SERVICE BULLETIN

SUBJECT: Norco, Inc. Strut Assembly A2711-3 rework to
A2711-15 by installation of Sleeve AM2711-15-2.

A2711-78-1

FIGURE 1 - STRUT ASSEMBLY A2711-15

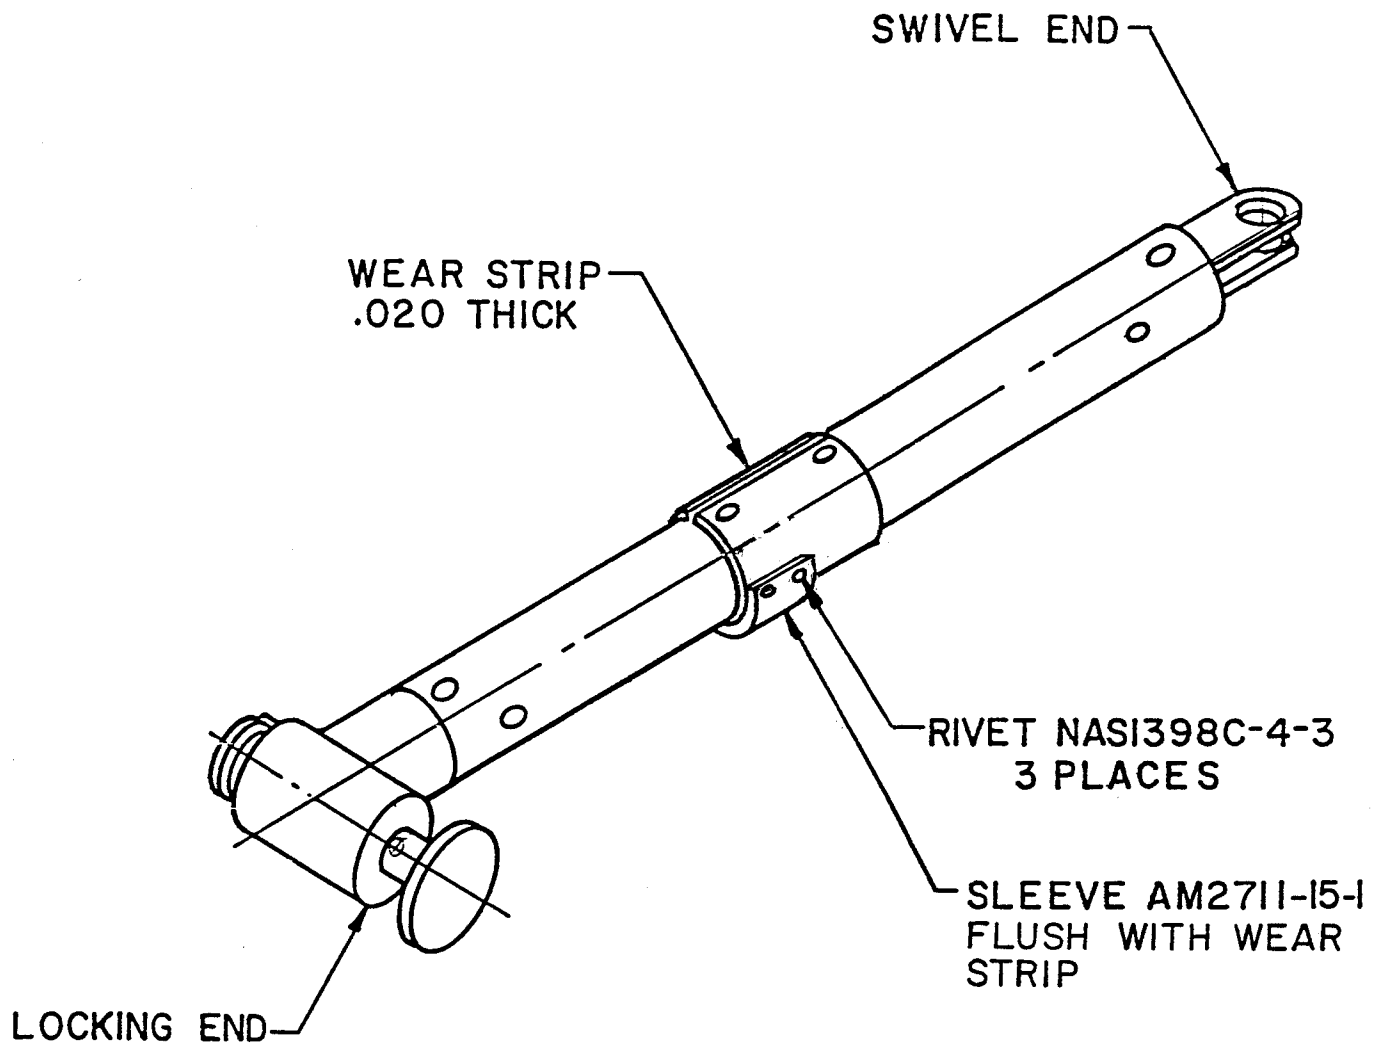
Prevent potential chafing of adjacent electrical harness.

1. Position sleeve (AM2711-15-2) as shown in Figure 1 and clamp in place.
2. Using sleeve (AM2711-15-2) as a drill template, drill through one wall with #29 drill (.136) in three places.
3. Remove sleeve (AM2711-15-2), deburr holes, and remove any loose metal chips.
4. Reposition sleeve (AM2711-15-2) and align with previously drilled holes.
5. Install one (1) NAS1398C-4-3 rivet and set rivet with installation tool.
6. Verify hole alignment on the remaining two (2) holes by inserting rivets and setting with installation tool.
7. Check that sleeve (AM2711-15-2) is tightly held at all three attachment points.
